UPPER WALLACE DAM

# PHASE I INSPECTION REPORT

## NATIONAL DAM SAFETY PROGRAM

**JULY 1980**

Photograph No. 4

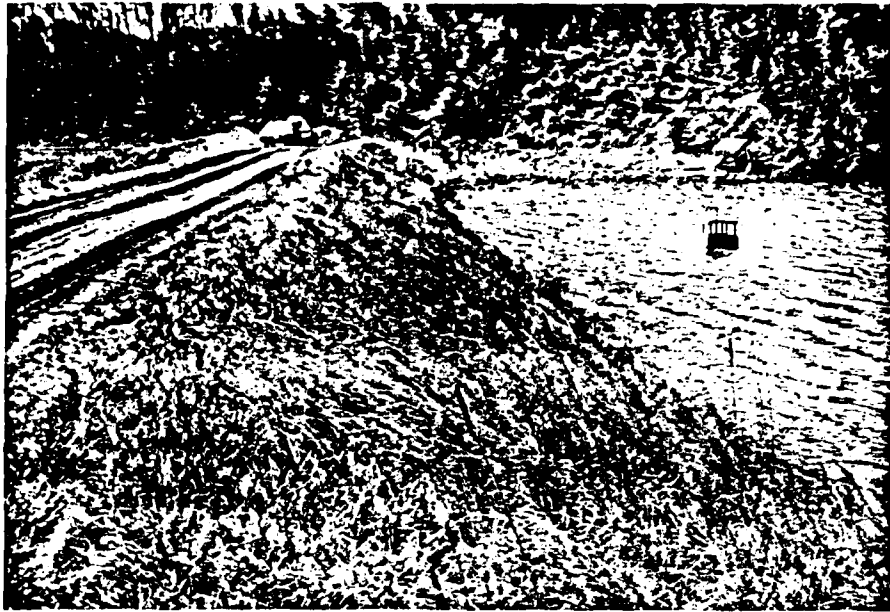
Emergency Spillway (Note Lack of Vegetation)

7.3.3 The emergency spillway should be reseeded to establish a good vegetative cover for erosion protection.

FIELD SKETCH

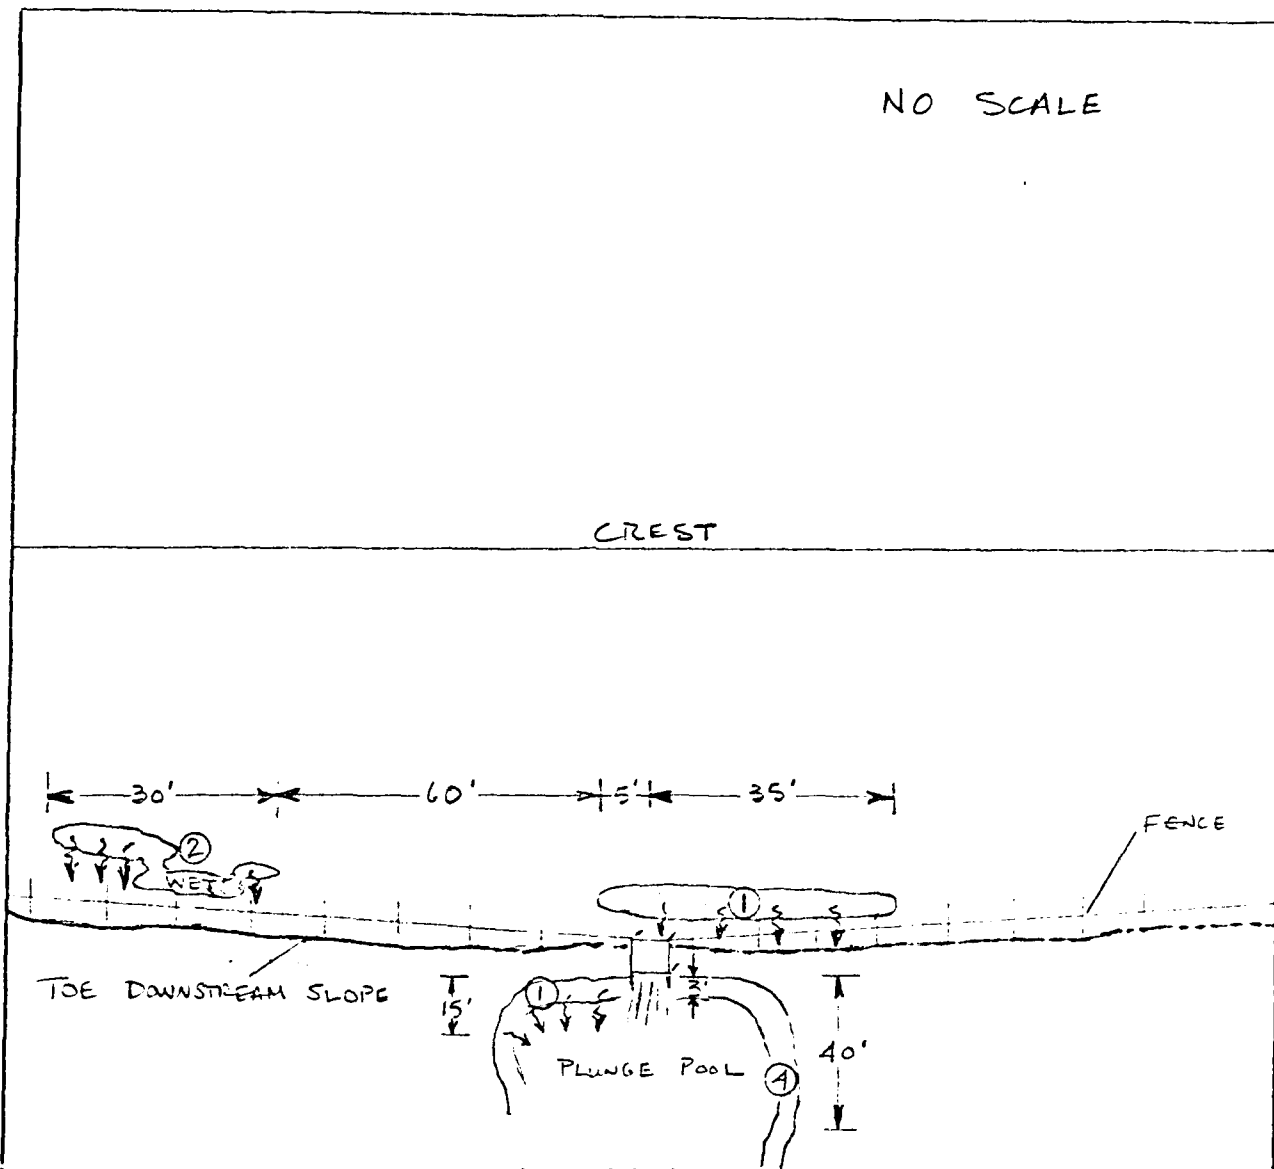
the vicinity of the outlet pipe and extending downstream. The field sketch in Appendix III illustrates the areas described.

- ① SEEPAGE 2 TO 5 FT ± ABOVE TOP OF OUTLET PIPE, SOME IRON STAINING, NO FLOW OBSERVED. GROUND SURFACE ON DOWNSTREAM SIDE OF FENCE ALSO INCLUDES SATURATED AREAS.
- ② THIS AREA CONSISTS OF TWO WET SPOTS WHICH COALESCE AT TOE OF SLOPE. THE LOWER SATURATED AREAS EXTEND 3 TO 5 FT ± ABOVE THE TOP OF OUTLET PIPE, WHILE UPPER AREA IS ABOUT 9 FT ± ABOVE. NO IRON STAINING OR FLOW OBSERVED.
- ③ SCATTERED SEEPAGE IN 15 FT ± WIDE AREA ALONG VERTICAL SLOPE, IRON STAINING, FLOW UP TO 1 GPM ±
- ④ INTERMITTENT IRON STAINING ALONG EDGE OF PLUNGE POOL
